**6624A-13**

# S E R V I C E N O T E

## 6624A DC Power Supply

### Intermittent Power Transformer “Magma” Connections

**Top View of Power Transformer:**

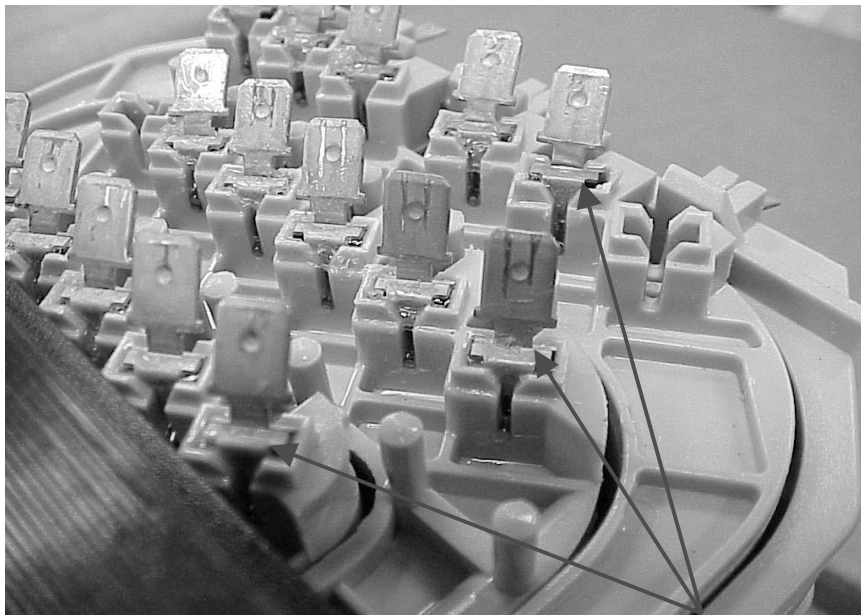
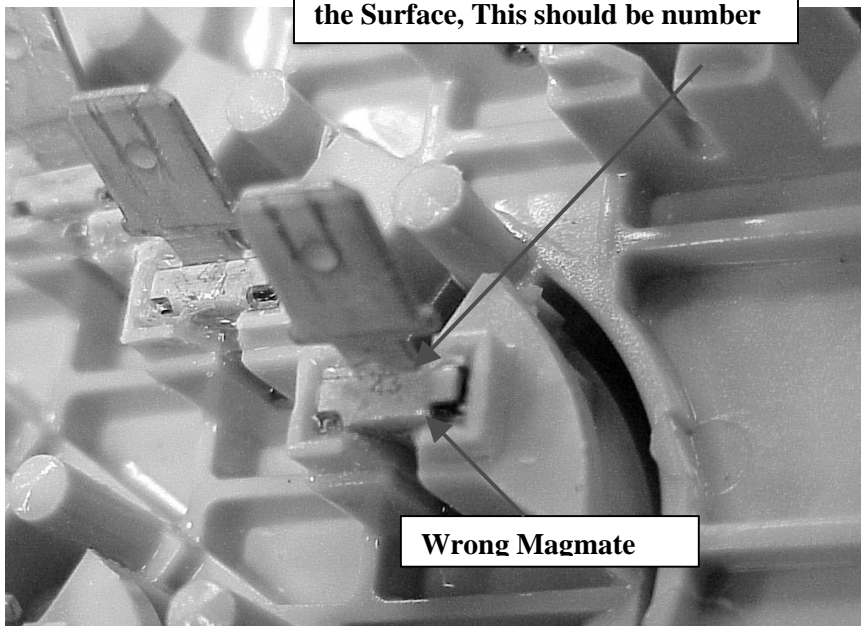
The power transformer vendor mistakenly installed the wrong “Magmates” in a run of power transformers. The incorrect “Magmates” have a # 43 stamped on them, which corresponds to a 15 gauge wire size. The correct size “Magma” should be # 24 designed for a 19 gauge wire size.

This could result in a variety of intermittent as well as steady hardware problems and errors. Examples: HDW ERR CH 1, Blank front panel display, not meeting specifications.

**Incorrect “Magma” number 43 on the Surface, This should be number**

**Wrong Magma**

Replace the Power Transformer with a new replacement Transformer, see the table above for the correct power transformer part number.

**NOTE:** Please inspect the new transformer for the correct “Magma” number stamping.
